Wineglass Bay Carpark and Lookout Track Site Plan 2004

Parks and Wildlife Service Tasmania

Report to the**General Manager****on****Public Representations Received on the *Freycinet National Park Draft Wineglass Bay Carpark and Lookout Track Site Plan 2004***

**Schedule of Public Comments and Proposed Responses
to the
Freycinet National Park Draft Wineglass Bay Carpark and Lookout Track Site
Plan 2004**

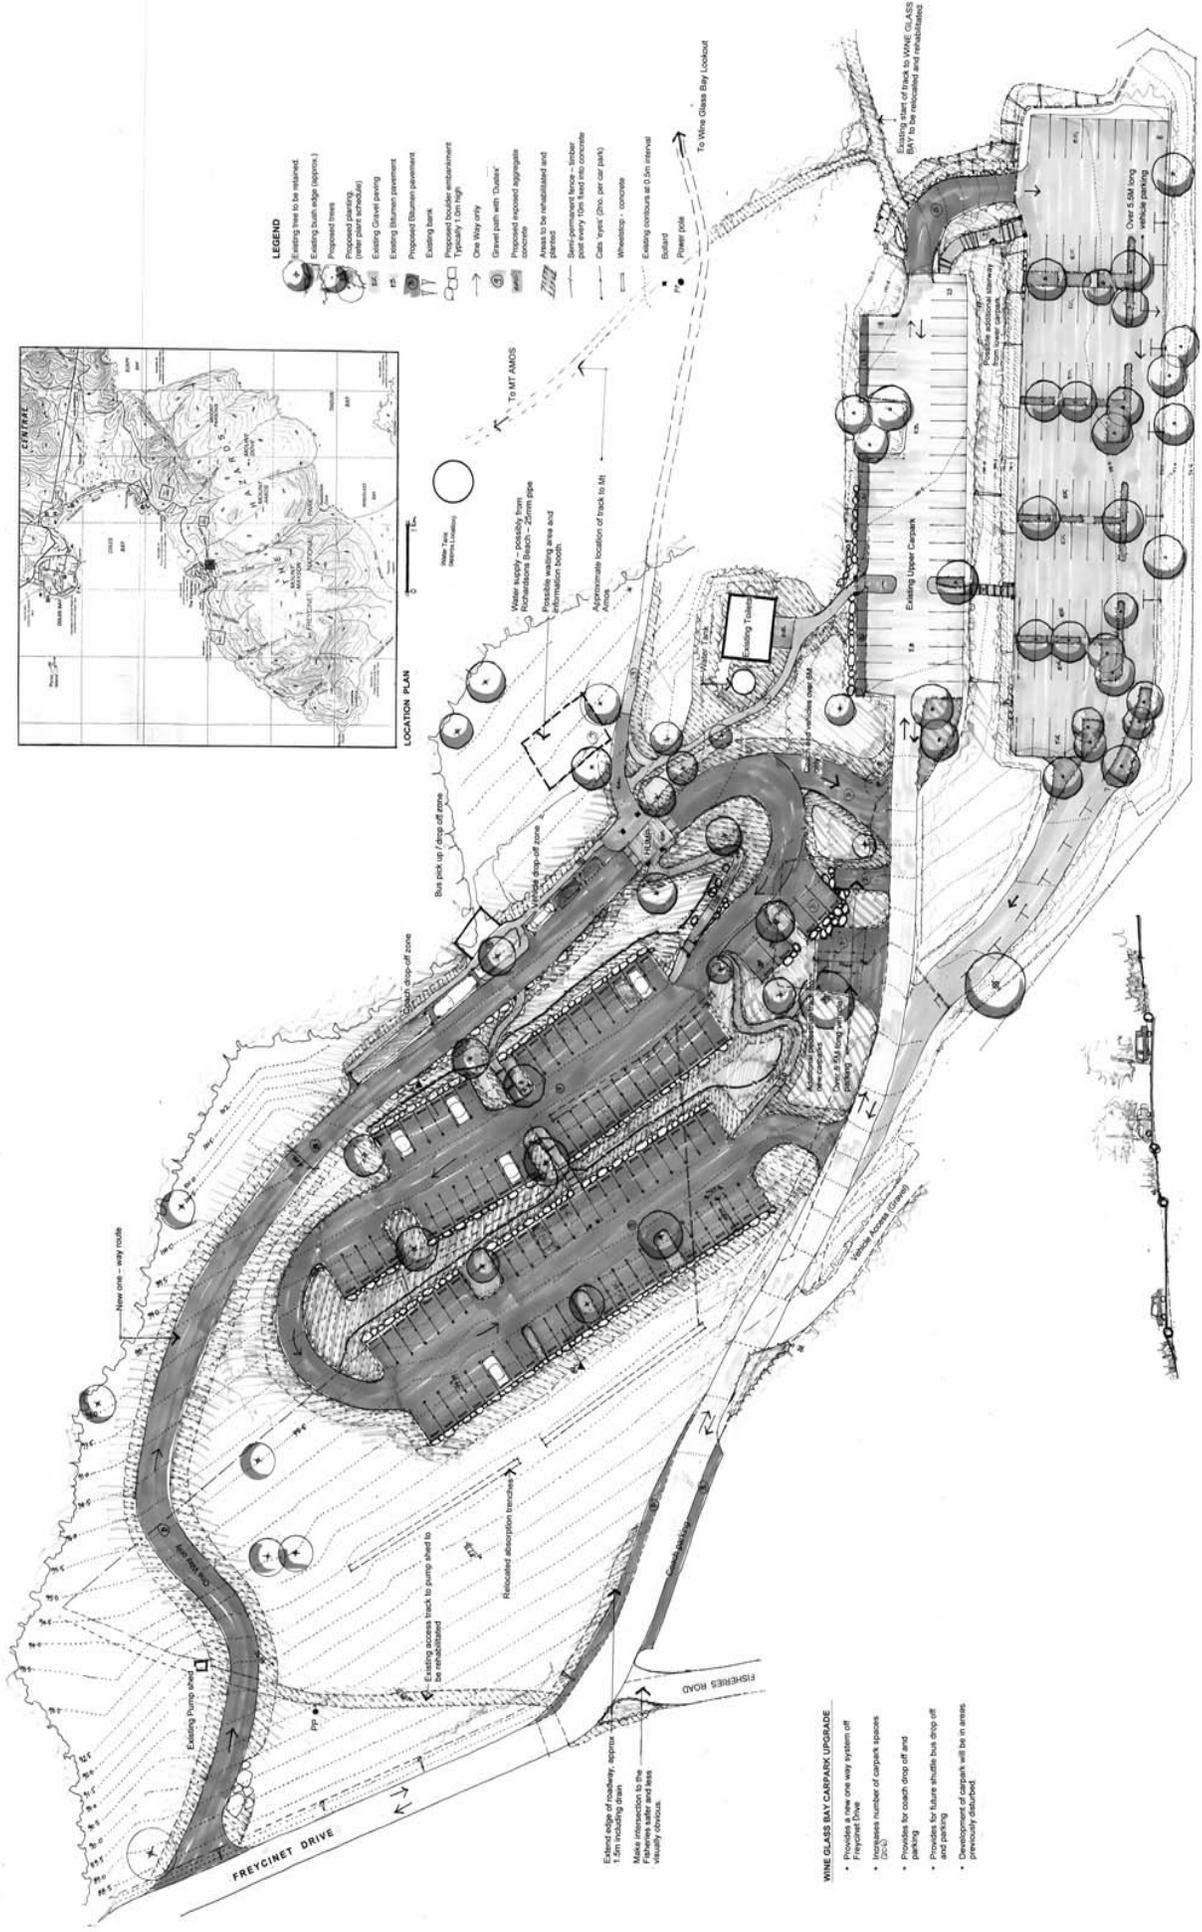
5. Frequent walker in the park	Noted.
6. I. The plan fails to recognise the substantial impact the expanded carpark will have on landscape and visual values. The carpark expansion will lead to: 'substantially increased visibility of cars and alienated ground from numerous higher vantage points, eg from the Mt Amos track.'	It is accepted that the plan, in considering visual sensitivity, focussed on views to the Hazards and failed to consider views from the Hazards. The carpark will be visible by walkers looking down from the many vantage points on the Hazards, and will impact on the overall naturalness of views obtained.

13. Very concerned for the proposed coach parking area between the two Fisheries turn-offs. It will obstruct the view of traffic exiting the fisheries, creating a dangerous situation.	This comment will be referred to the carpark's design engineer for his comment, and, if deemed appropriate, design amendment.

Comment	Proposed Response
27. 4.1 Disagree with doubling the current carpark size. It will have visual impact, and its overall effectiveness is questioned. The numbers put up in the site plan indicate the limit requiring alternate solutions has already been reached.	See response to comments #6 and 7.

Comment	Proposed Response
	<p>In considering this issue several ameliorating aspects are apparent, viz:</p> <ul style="list-style-type: none"> • The carpark is right next to a fairly intensely developed holiday residential area at the Fisheries, and will, when seen from above, read as an extension to it. • The new carpark will be sealed, providing a much lower reflectivity and visual contrast to an unsealed carpark. It is however accepted then when the carpark is full the vehicles themselves are highly reflective. • The existing large trees across the new carpark site have been, to the extent possible, incorporated into the carpark design. They will provide substantial screening when viewed from above. • In the long-term it is planned to reduce the amount of carparking at the site, thereby reducing the overall impact. <p>In conclusion, while accepting that the carpark will impact on views from above, it is believed the issue is not sufficiently serious to warrant a major rethink of the current approach.</p>

Figure 2 - Lookout Track Site Design

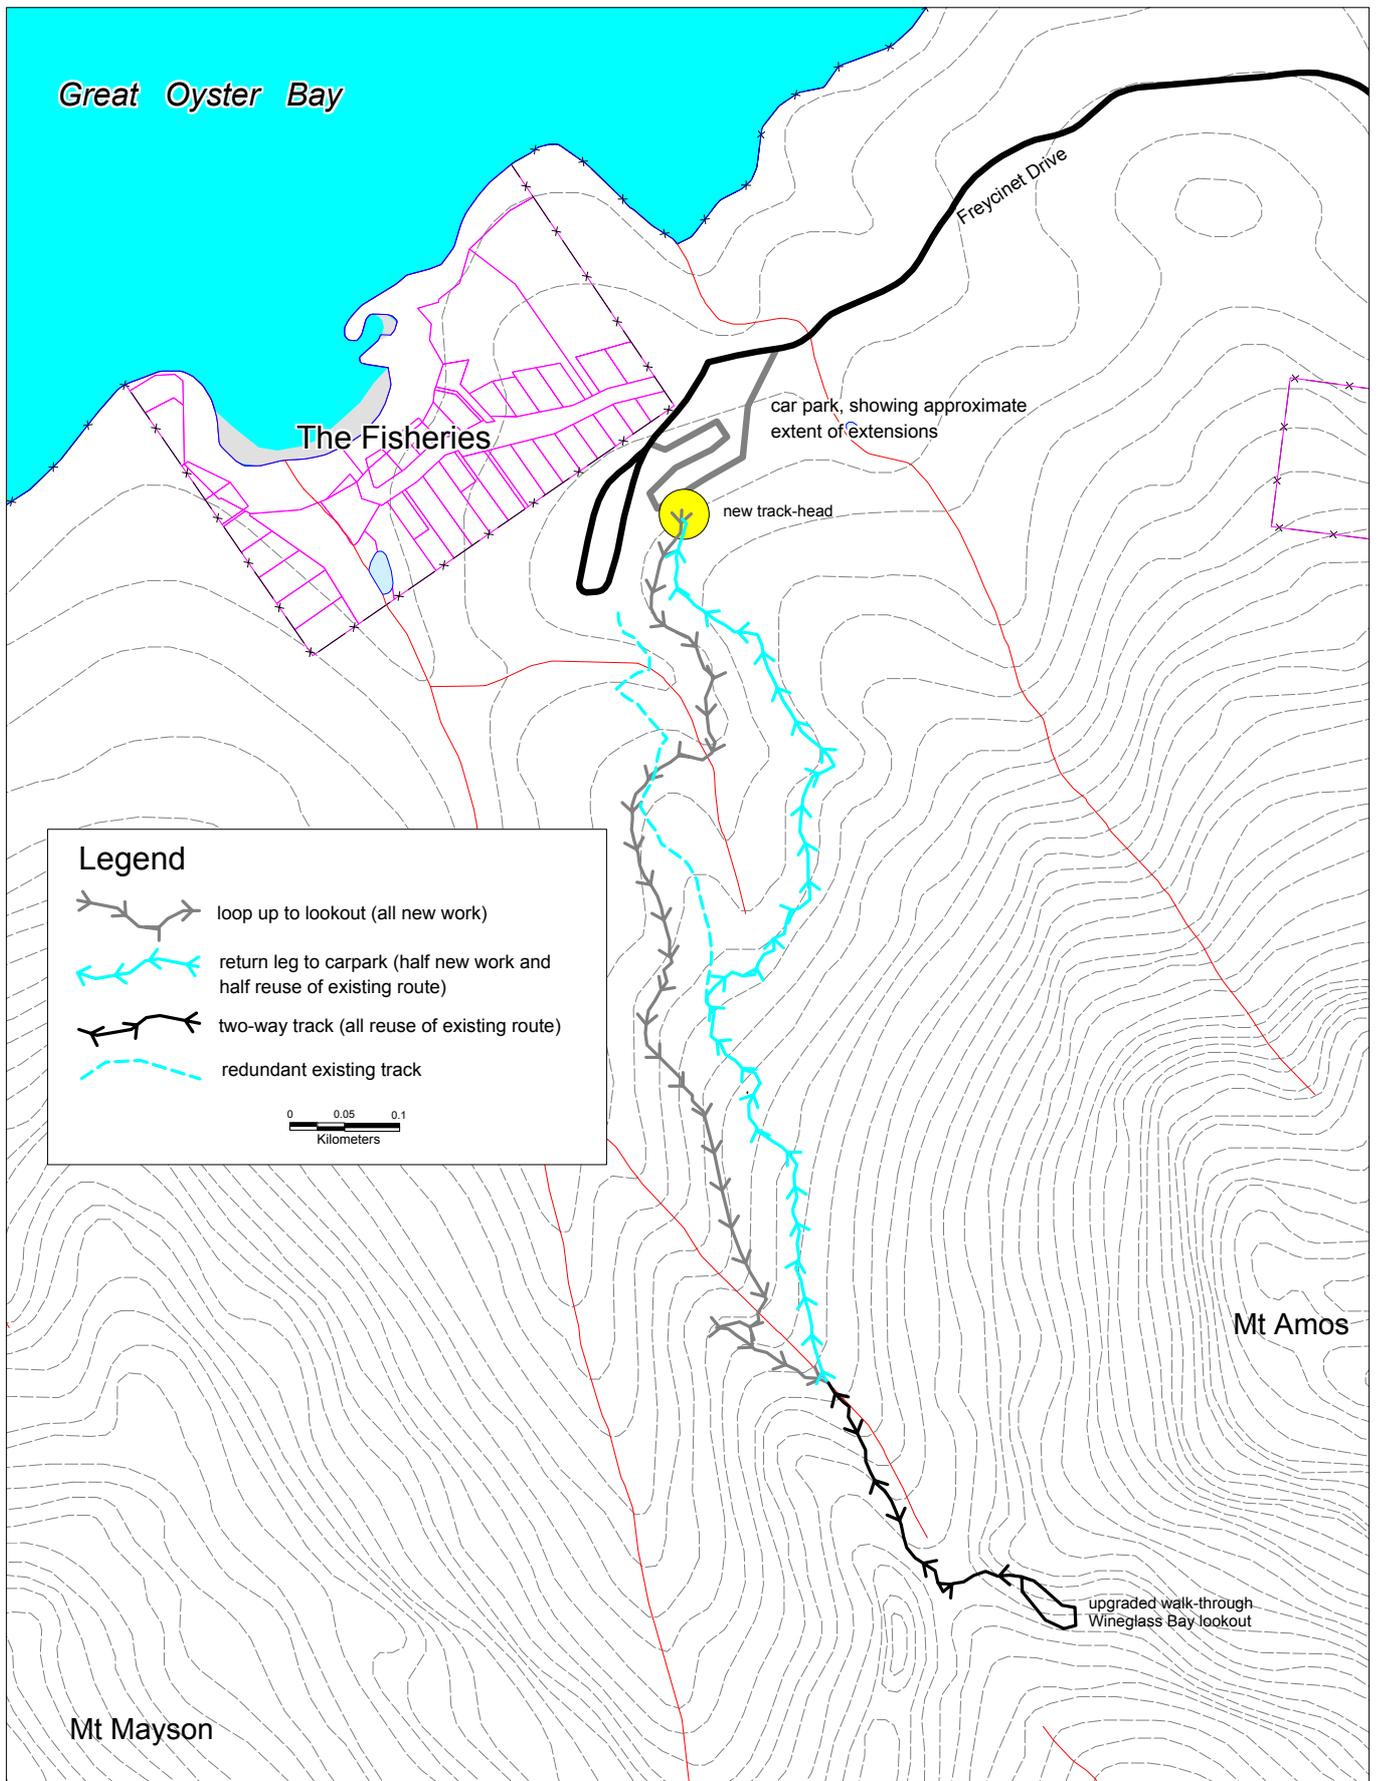
10. IV. Strongly disagree with a one-way traffic system on the loop track, it being too regimented and also increasing the frequency of overtaking encounters.	See response to comment #11.

30. Track Plan Rather than a mostly one-way system, suggest two 2-way tracks, one slower and gentler, the other faster. The reason for this being that there are many users who progress very slowly, causing frustration for fitter, faster walkers.	See response to comment # 11.

51. Applying this method to the 'pink route' would lessen environmental impact and maintain the 'destination' character of the walk.	These comments seem to reflect a belief that the loop-track route shown in the site plan does not utilize the 'pink route'. In fact the loop-track route identified in the plan utilises a combination of the route of the existing track and the 'pink route'. John Hughes has endorsed the proposed route.

56. Track Plan Support the loop system, but disagree with making the return downhill loop the shorter, steeper leg. For safety it should be the other way round.	The management authority acknowledges this concern and considers the respondent may well be right. This is the reason for the wording of Section 4.3 which says: While an anti-clockwise circulation pattern is currently being proposed, a final assessment of the correct circulation pattern will be made once construction has been completed. In any case these comments will be forwarded to the track design team.

11. Respondent prefers to walk against the traffic on a one-way system. The respondent finds being stuck behind a large group of people is frustrating. This problem would be exacerbated by the introduction of shuttle buses. Passing bays are an inadequate response. Both tracks should be two-way.	<p>It is noted that the proposed changes may cause the respondent some frustration. However the creation of one relatively short length of one-way loop track in a park that has many more kilometres of two-way track is considered acceptable.</p> <p>The Wineglass Lookout is one of Tasmania's premier tourism icons. As visitor numbers increase it is important that the experience be carefully managed to maintain quality. Feeling overcrowded has been demonstrated to reduce the quality of natural area experiences.</p> <p>Development of a one-way loop track system is a well-recognised approach to managing this issue. At the heart of the concept is a major reduction in apparent level of crowding. Parties move around the system at approximately the same speed, minimising encounters with each other.</p>
